# Erratum #1 for Exhibit 384

## Editorial correction:

Figure 4-5 Hydraulic Conductivity Distribution in Layer 1

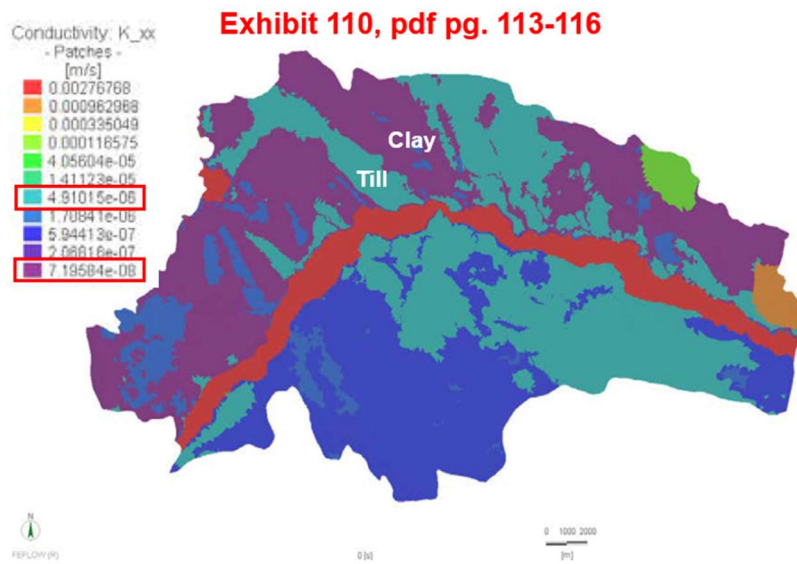
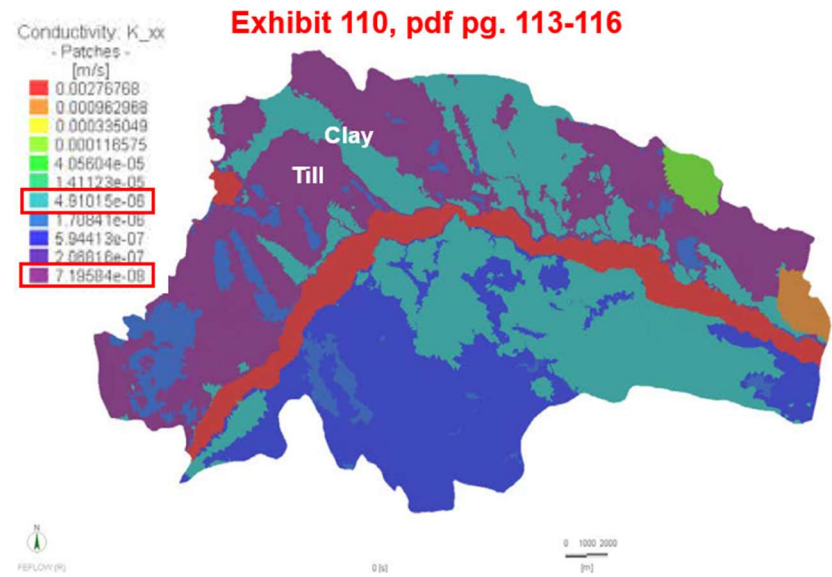
1. A correction is required to Exhibit 384, pdf pg. 14. The white-text labelling on the left larger image on the slide showing the Hydraulic Conductivity Distribution in Layer 1 of the groundwater model indicating “Clay” and “Till” needs to be shifted as follows: the “Clay” should be associated with the turquoise-coloured area (aligning with a K value of  $4.91015 \times 10^{-6}$  m/s in the legend on the left-hand side of the slide) and the “Till” should be associated with the purple-coloured area (aligning with a K value of  $7.19584 \times 10^{-8}$  m/s in the same legend). The previous and corrected images are provided below:

The revision made to the slide image depicting the location of the “Clay” and the “Till” does not change the interpretation or associated conclusions made by me in evidence (i.e. provided in Exhibit 261 and Exhibit 384).
